SUBJECT: Forwards permanent mod. details to Unit 2 600-volt motor control ctrs & 4 kV & 500-volt switchgear buses/cabinets per 810817 ltr. Adds to Unit 1 support welding at rear of reactor & generator trip breakers per 810824 ltr also encl.

AEP:NRC:0486B

Donald C. Cook Nuclear Plant Unit Nos. 1 and 2
Docket Nos. 50-315 and 50-316
License Nos. DPR-58 and DPR-74
Request for Relief from Technical Specification
Section 3.0.3

ATTACHMENT A
TO

PLAN - ADDITIONAL ANCHOR LOCATION

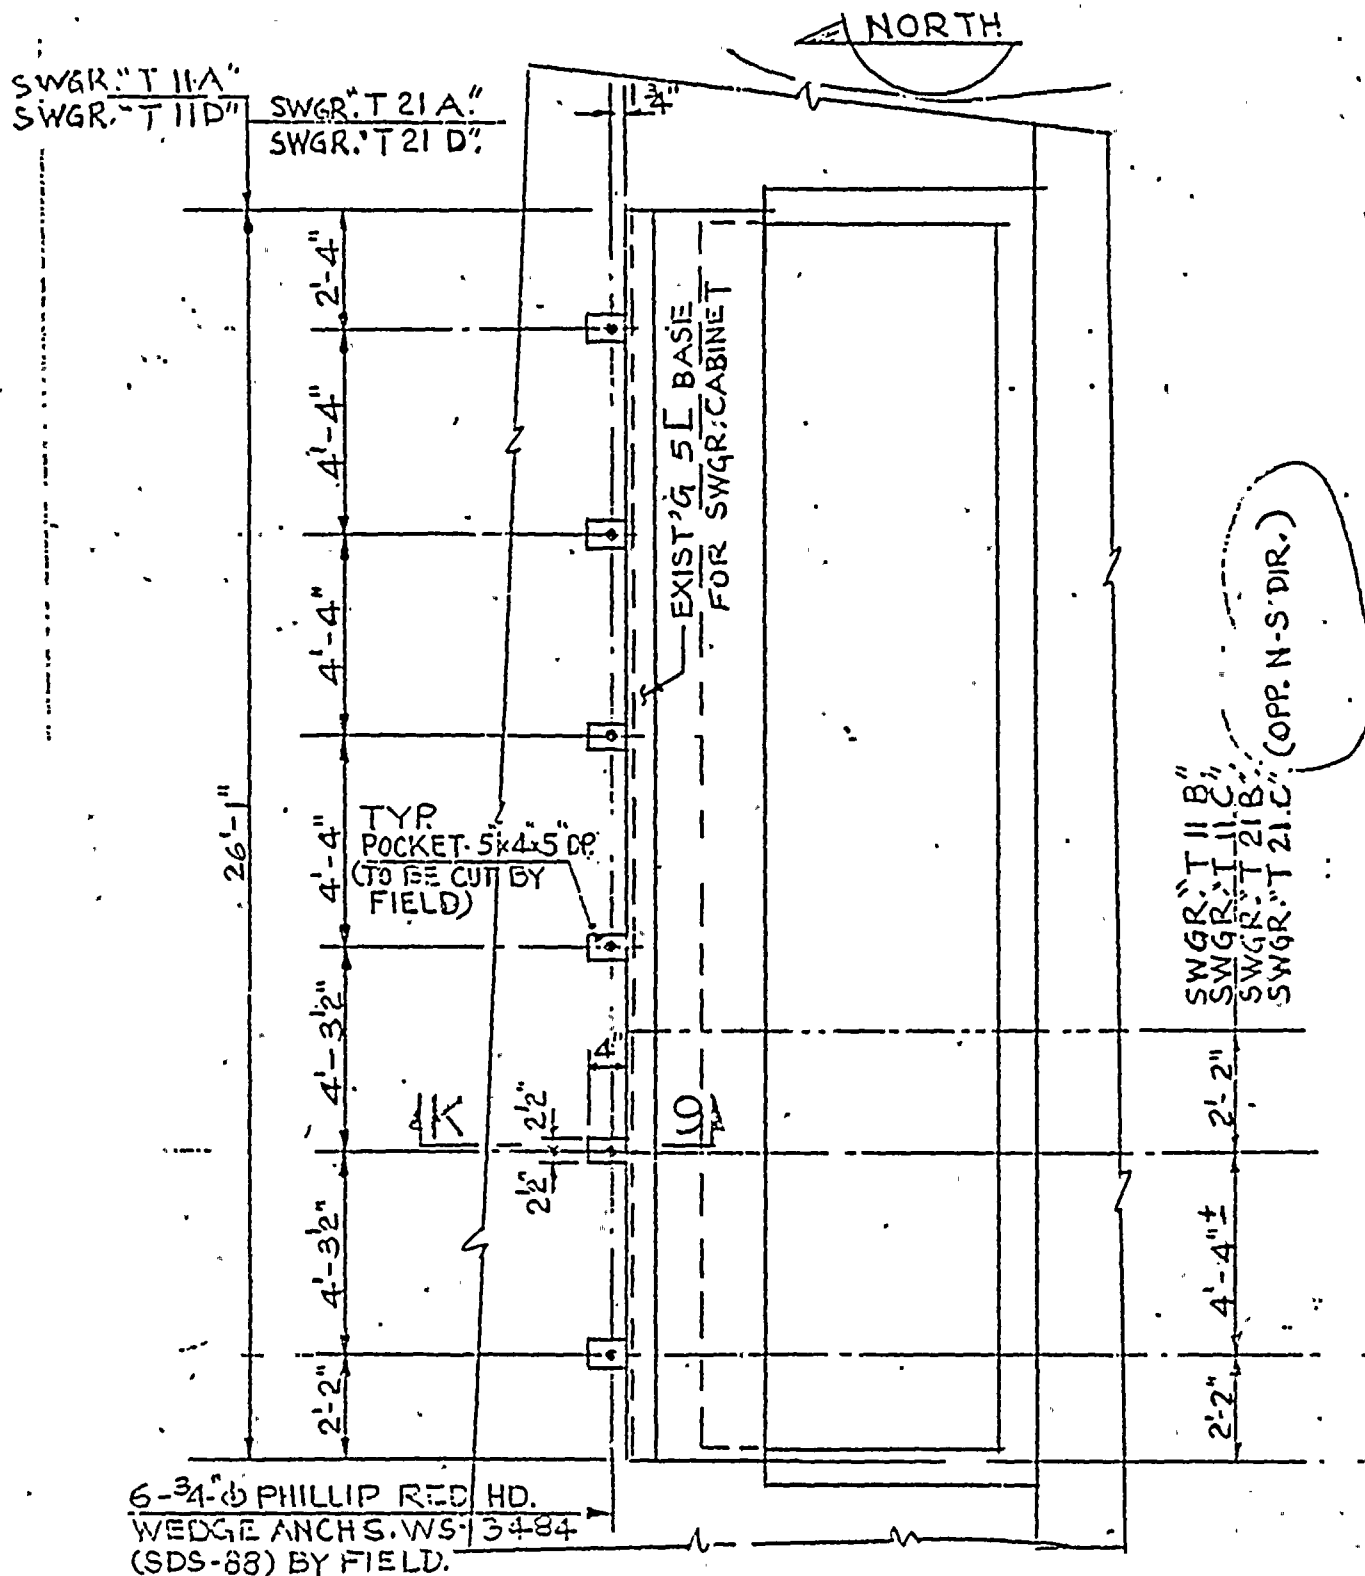
FOR SWGR. BUS: UNIT #1 "T 11 A", E, C & D (DWG. 12-3474
(N. T. S.) UNIT #2 "T 21 A", E, C & D (DWG. 12-3476

REACTOR AND GENERATOR TRIP BREAKERS

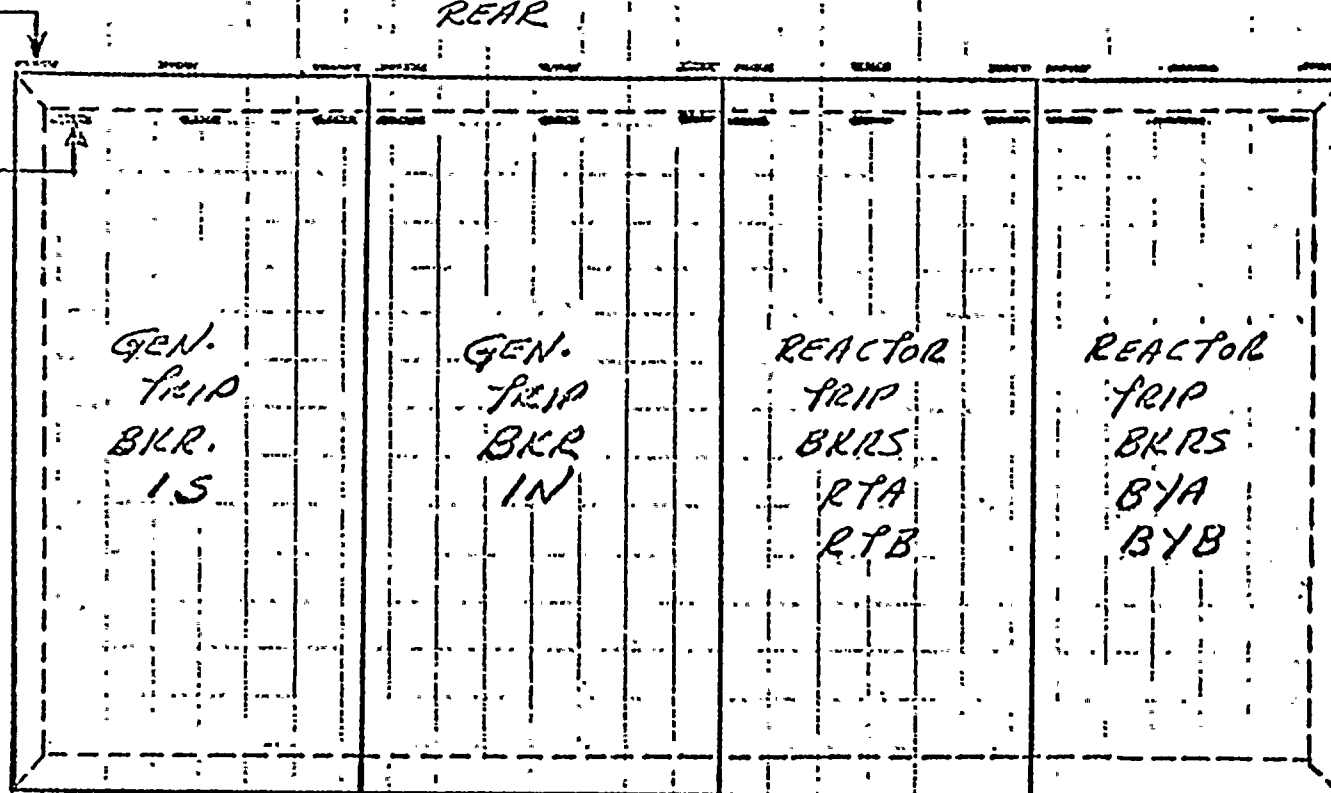
BASE OF
CABINETS
WELDED TO
BASE FRAME
WITH
3 - $\frac{1}{4}$ " X 3" LG.
FILLET WELDS
FOR EACH CAB.
WELDS TO BE
PLACED SYM-
METRICALLY AT
REAR OF EACH
CAB. - WELDS
CAN BE MADE
EITHER
INTERNALLY OR
EXTERNALLY
